Access Compliance Report

Public Rights-of-Way

Intersection ID: 10025367	Main Street: E_8TH_ST	Cross Street: N/A	Location: W
ADA ID: 3AE7D740AEEC	Ramp Type: Perp	Initial Pass/Fail: Pass	Overall Compliance: No
Severity Score: 2.5			
Codes/Mitigation Info/Possible Solution		Field Measurements/Component Compliance

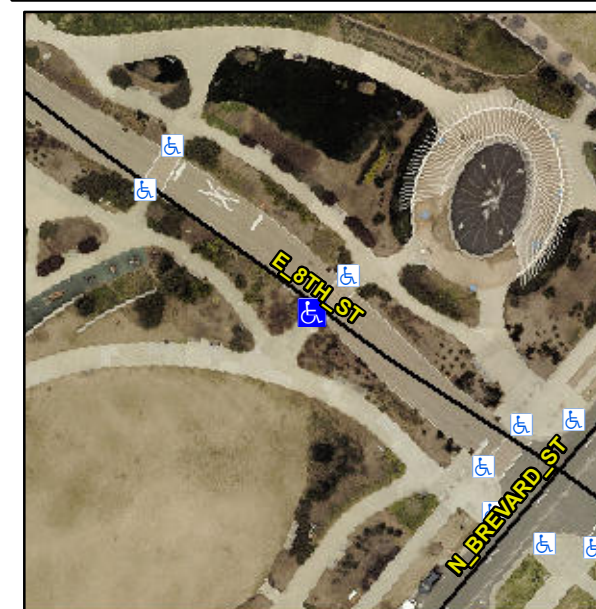
**Remove & Replace Entire Ramp.
Remove & Replace Gutter.**

**R304.2.2-Perp, R304.3.2-Para,
R305.1.4, R304.5.3**
